ADDENDUM NO. 01

TO SPECIFICATIONS AND CONTRACT DOCUMENTS FOR INVITATION TO BID TPO ROOF RETROFITS AT TMT AUTO FACILITY JPA CONTRACT NO.: MC-2108N

JPA CONTRACT NO.: MC-2108N

RESPONSE TO QUESTION(S)

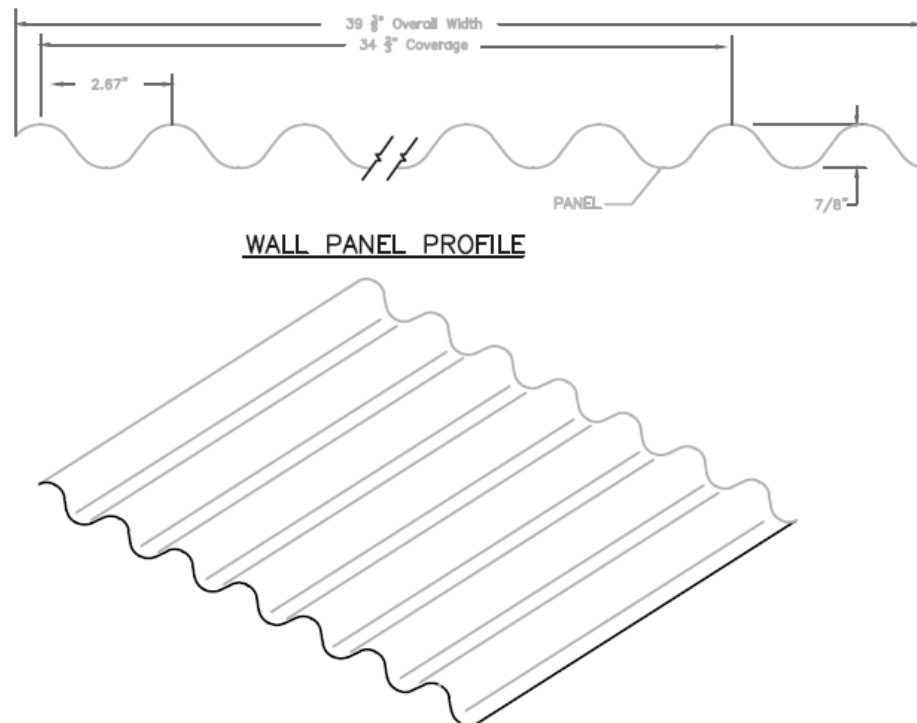
8. Please clarify which penetrations must be wire brush/prime/coated? Please provide basis of design for the coating.

ANSWER: The contractor shall carefully review drone photos/videos to identity rusted penetrations.

Transit Shed Estimate – 2 large fans, 10 medium vent pipes, 9 small vent pipes
Accessory Shop Estimate – 7 fans
